Alamitos Energy Center

(13-AFC-01)

Data Responses, Set 8 (Response to Data Request 170-175)

Submitted to
California Energy Commission

FIGURE DR173-1R
Electrical System One-Line Diagram
Alamitos Energy Center
Long Beach, California
March 2016

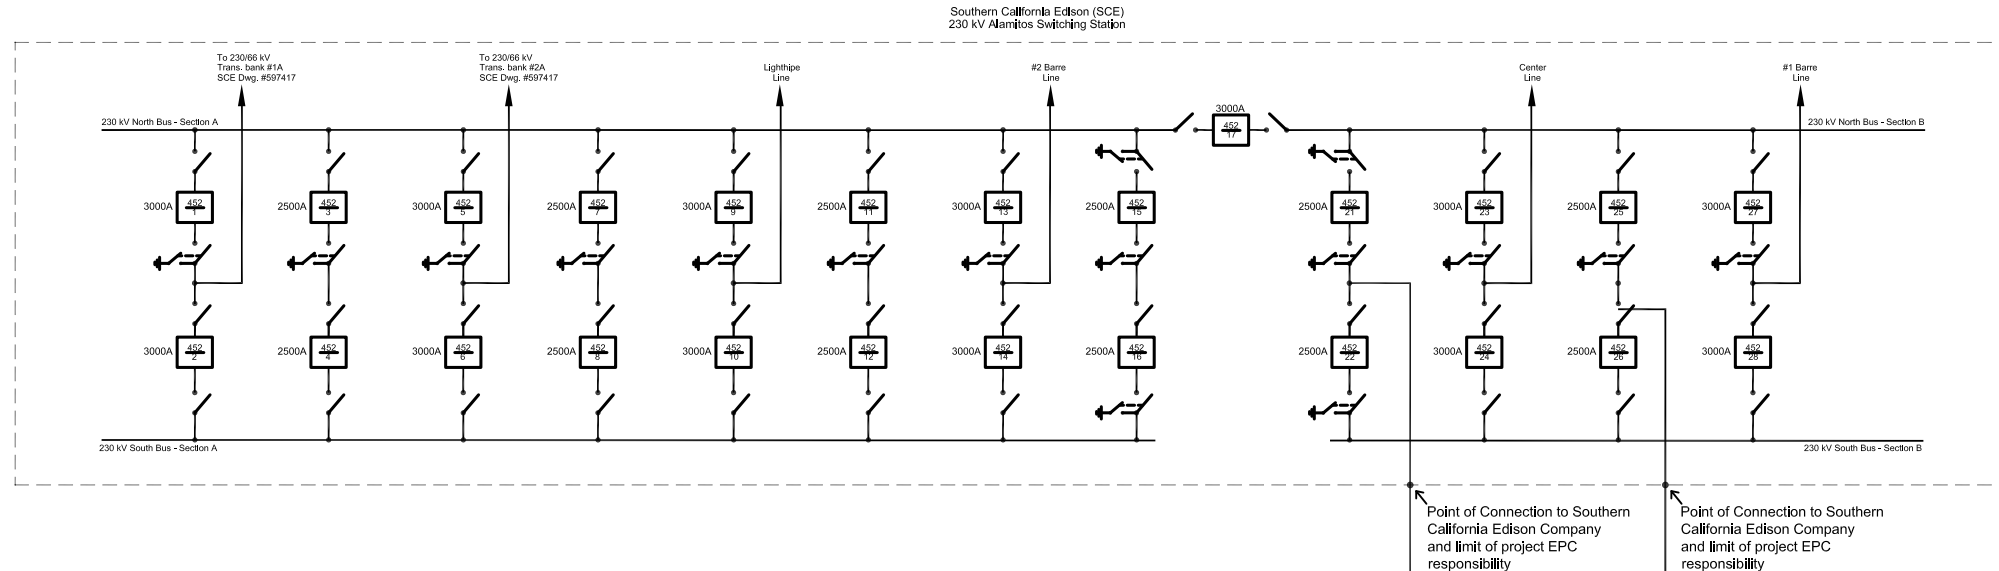
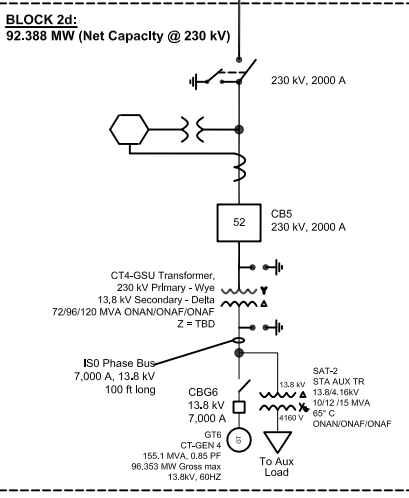
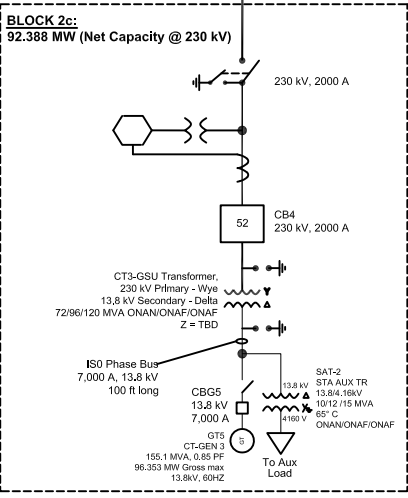
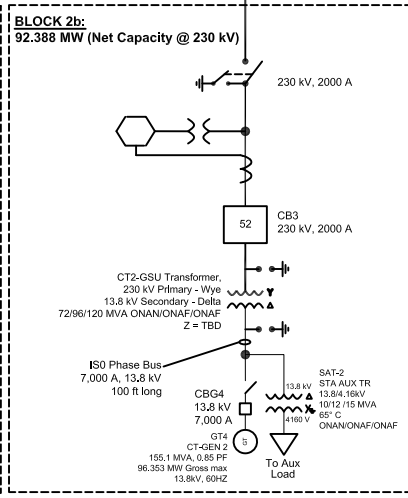
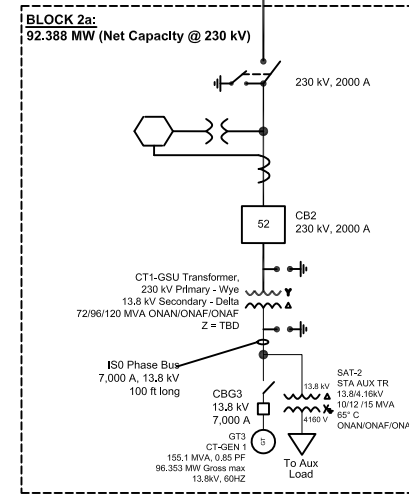
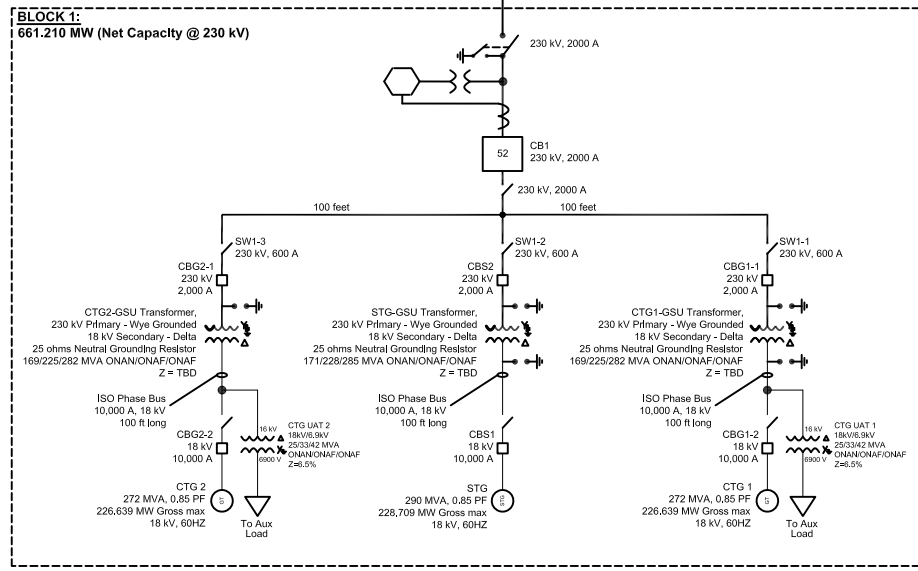
173. Figure 3.1-1R and Figure DR161-1R are not consistent. Figure 3.1-1R shows four power blocks, 2a, 2b, 2c and 2d, connecting separately to the bus. Figure DR161-1R shows blocks 2a and 2b connecting as a pair to the bus and 2c and 2d connecting as a pair to the bus. Please provide consistent drawings.

174. Given the discussion above and the high operating temperature ACSS conductor proposed in Figure 3.1-1R, please explain the choice of the ACSS conductor for the gen-tie line and why a more standard ACSR conductor was not chosen.

175. Many of the circuit breakers and all of the Step-up transformers are not rated highly enough to allow the generators to operate at their rated 0.85 power factor.

- a. Please explain the choice of underrated equipment or redesign the switchyard and gen-tie lines with equipment that would allow the generators to operate at their rated 0.85 power factor (0.85 lag). If the switchyard is redesigned, resubmit all of the diagrams with the new equipment and the associated equipment ratings.

b. The 9,000 Amp, 18 kV Circuit Breaker 1 (CB1) in the Power Block No. 1 switchyard would not allow the STG to operate at its rated 0.85 PF.

e. In Power Block 1, the 230 kV breaker, CB1 and associated disconnect switch are rated at 2,000 Amperes. In order to accommodate generators at 0.85 PF, the ratings of the 230 kV breaker and the disconnect switch should be at least 2, 100 ampere.

Response: Figure DR173-1R presents a revised electrical system one-line drawing that is consistent with Figure DR161-1R. Figure 2.1-2R presents the revised general arrangement.

Response: The ACSS conductor was selected because it has superior mechanical properties and corrosion resistance. The electrical properties and ratings of ACSR and ACSS bare transmission conductors for any given size are nearly identical. Both types of conductors have the same area of aluminum conductor, the same alternating current (AC) resistance, and will operate at the same conductor temperature for any given conductor size and load. The ACSS type conductor is superior due to the higher quality steel support core and compressed trapezoid aluminum conductor. This allows the conductor to operate at temperatures up to 200 degrees Celsius; however, the application for the AEC will limit the maximum cable temperature to below 75 degrees Celsius. The ACSS conductor was selected because of its higher strength, lower susceptibility to sag, and more importantly it is corrosion resistant in a saline coastal environment. Given that the electrical properties and operating temperatures of ACSR and ACSS conductor are the same, the premium ACSS conductor with its superior mechanical properties and corrosion resistance are proposed for AEC.

Response: The equipment is not underrated as demonstrated by the following calculations. It appears that the CEC staff has used the nameplate rating of the combustion turbine and steam turbine generators in the calculation of the maximum electrical loads. The AEC generator loadings for the combustion turbine generators and steam turbine generator will be limited by the available shaft horsepower from the combustion turbines and steam turbine. The electrical generators are oversized and will not operate at their nameplate ratings. As noted in the SAFC Figure 2.1-4a, the maximum output of the combustion turbines in combined cycle power block is limited to 226.639 gross megawatts (MW) under cool weather conditions, and the steam turbine generator is limited 228.709 MW due to the available steam. If these generation ratings are used to calculate the maximum transformer and equipment loads for all equipment, they will be found to be sufficiently sized for operation at a 0.85 power factor should it ever be required. Please note that the current power factor requirement for generators operating in the California Independent System Operator (CAISO) has been unchanged at 0.90 lagging to 0.95 leading since the creation of the CAISO. Under the current CAISO Tariff requirement, the power factor for the Alamos Energy Center electrical equipment has a comfortable rating margin.

Response: The breaker is properly rated as demonstrated by the following calculations. The maximum steam turbine generator output is 228.709 MW per SAFC Figure 2.1-4a. At a power factor of 0.85 this equals 269.069 MVA resulting in a maximum loading of 8,630 ampere at 18 kV. This is within the rating of the 9,000 ampere circuit breaker. As noted in the response to Data Request #173, the engineering design is ongoing and this breaker will be provided with a 10,000 ampere rating for consistency with the 2 – 10,000 ampere breakers on the 2 combustng turbine generators in the power block.

Response: The disconnect switch is properly rated as demonstrated by the following calculations. The maximum combined cycle power block 1 output is 661.210 MW (net) under cool weather conditions per SAFC Figure 2.1-4a. At a power factor of 0.85 this equals 1,660 ampere and is within the ratings of the 2,000 ampere circuit breaker and 2000 ampere disconnect switch.
